# Groundwater Application Review Summary Form

Application # G- 19432

GW Reviewer Stacey Garrison Date Review Completed: 5/13/2025

**A. GENERAL INFORMATION:** Applicant's Name: The Nursery Outlet c/o Sergi Ovchinnikov County: Marion

Well Statistics

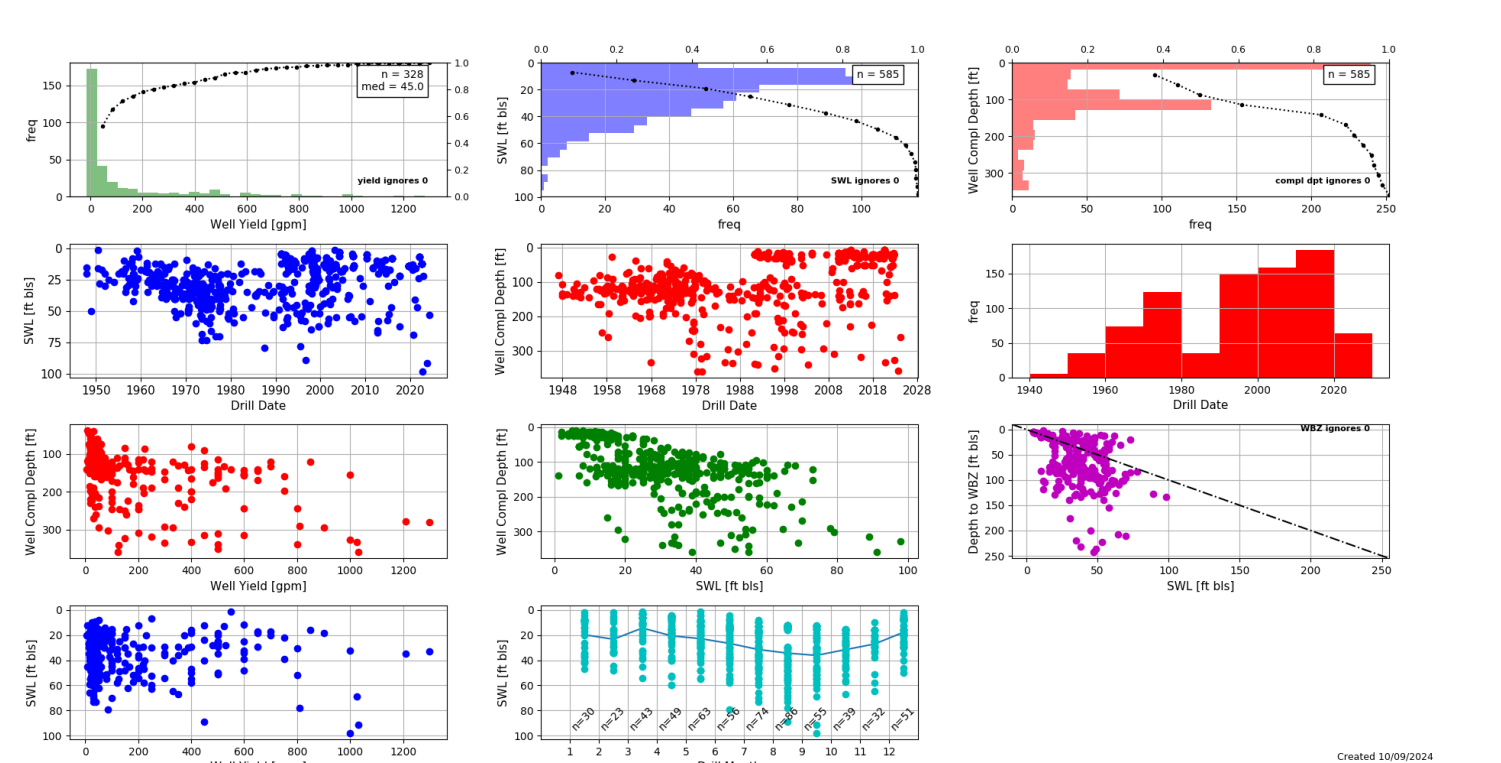
A review of statistics for nearby well records was completed and compared with the proposed maximum rate of 0.033 cfs (14.8 gpm) for this application (see **Well Statistics**). The median reported well yield is 45 gpm, and the maximum reported yield is 1,300 gpm. The proposed rate for this application is 33% of the median and 1% of the maximum reported yield. Within a mile of the proposed POA, well yields range from 15 to 1,300 gpm with a median of 337.5 gpm. The proposed maximum rate of 0.033 cfs (14.8 gpm) is likely within the capacity of the groundwater resource.  
Water level trends for wells that utilize alluvial aquifers within a mile of the POA appear to be stable (see **Water Levels Measurements in Nearby Wells**). Although notable declines have occurred in MARI 50856 and MARI 2218, these declines do not meet the Division 8 criteria for Declined Excessively or Excessively Declining. There are 35 groundwater POAs on 50

### Water-Level Measurements in Nearby Wells

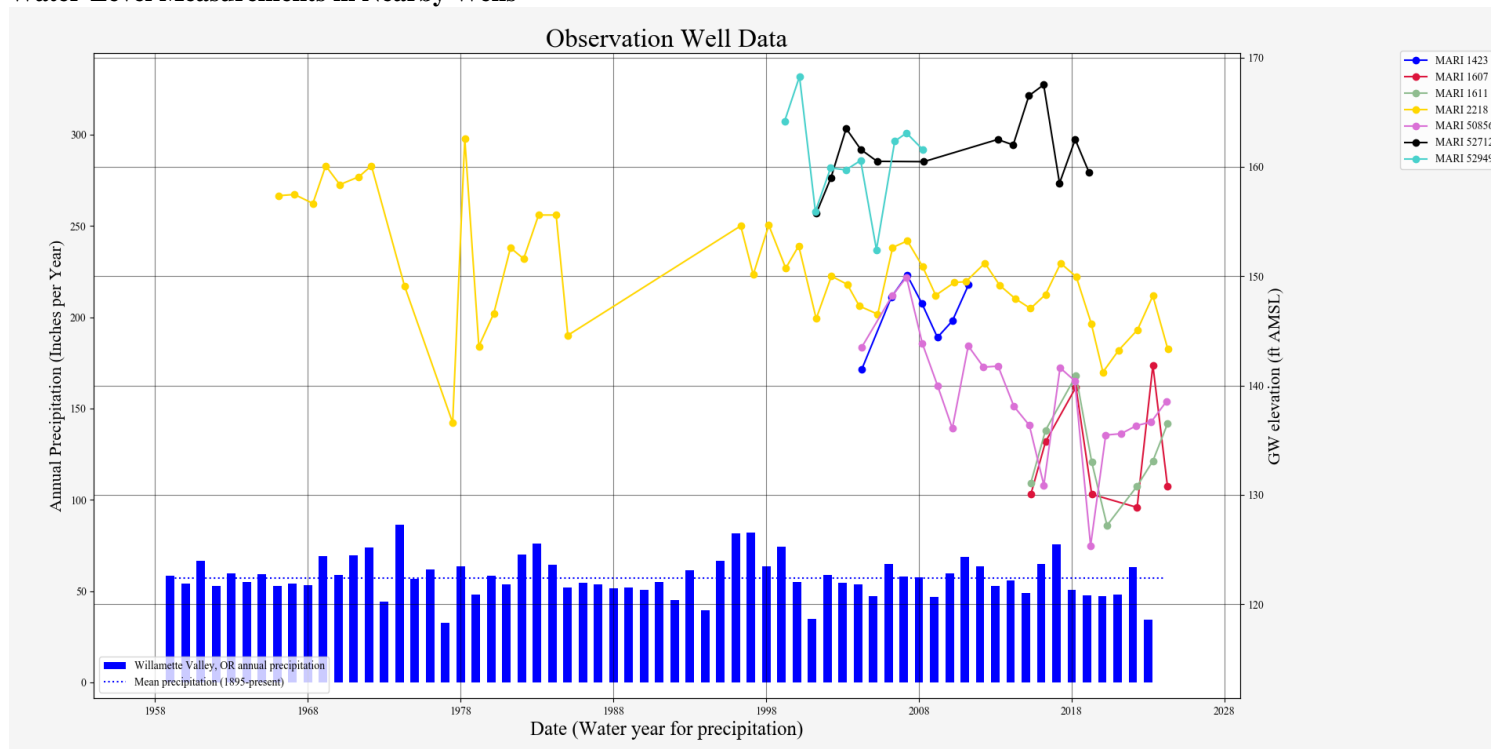
water rights within 1 mile of the subject POAs. However, the steady trends in water levels indicate that the groundwater resource is not likely over-appropriated and the proposed use is within the capacity of the resource.

### Theis Interference Analysis

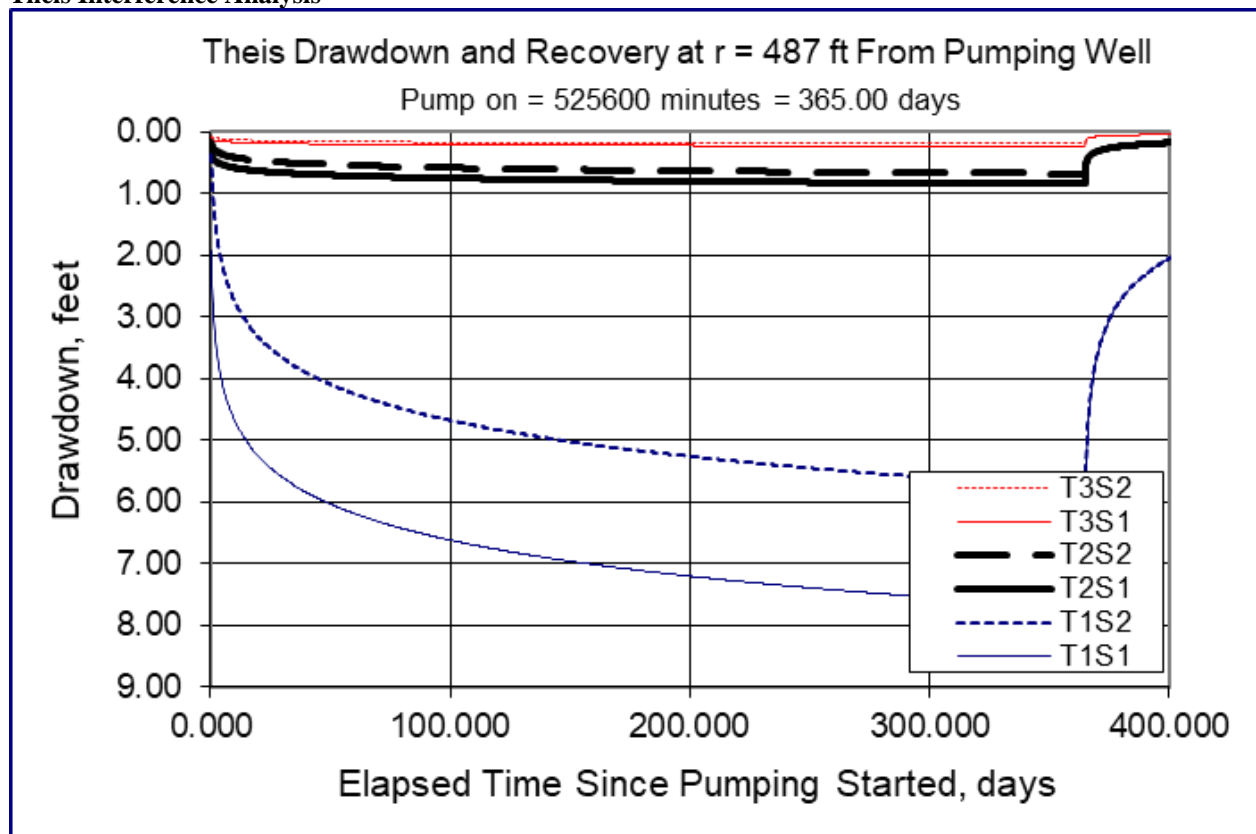
The nearest groundwater user to the POA is MARI 50856, located 487 ft southeast of the POA (MARI 1574), at an elevation of 183 ft amsl. It is likely the proposed use would cause some degree of well-to-well interference with MARI 50856. To assess the degree of drawdown, a Theis drawdown analysis was conducted for the proposed use (see **Theis Drawdown Analysis**). Results indicate that the proposed use is not likely to cause well-to-well interference with MARI 50856 that exceeds the threshold under the standard condition for alluvial aquifers in the Willamette Basin.

Radial distance from pumping well ( $r$ )=487 ft [estimated radial distance to nearest user, MARI 50856]

**Pumping Rate ( $Q$ )= 0.033 cfs (~ 14.8 gpm)**

Aquifer Transmissivity ( $T_1$ )= 2,010 gpd/ft (270 ft<sup>2</sup>/day), ( $T_2$ )= 23,188 gpd/ft (3,100 ft<sup>2</sup>/day), ( $T_3$ )= 92,969 gpd/ft (12,429 ft<sup>2</sup>/day)

Storativity ( $s_1$ ) = 0.0001, ( $s_2$ ) = 0.001 [Conlon et al 2005, Table 1 and 2 values for MSU]

Total pumping time=365 days [Year-round nursery]

Based on this analysis of the available data and under the assumptions previously identified, groundwater for the proposed use will likely be available in the amounts requested and within capacity of the resource. The conditions specified in B1(d)(i) and B2(c) are recommended to protect senior users and the groundwater resource.
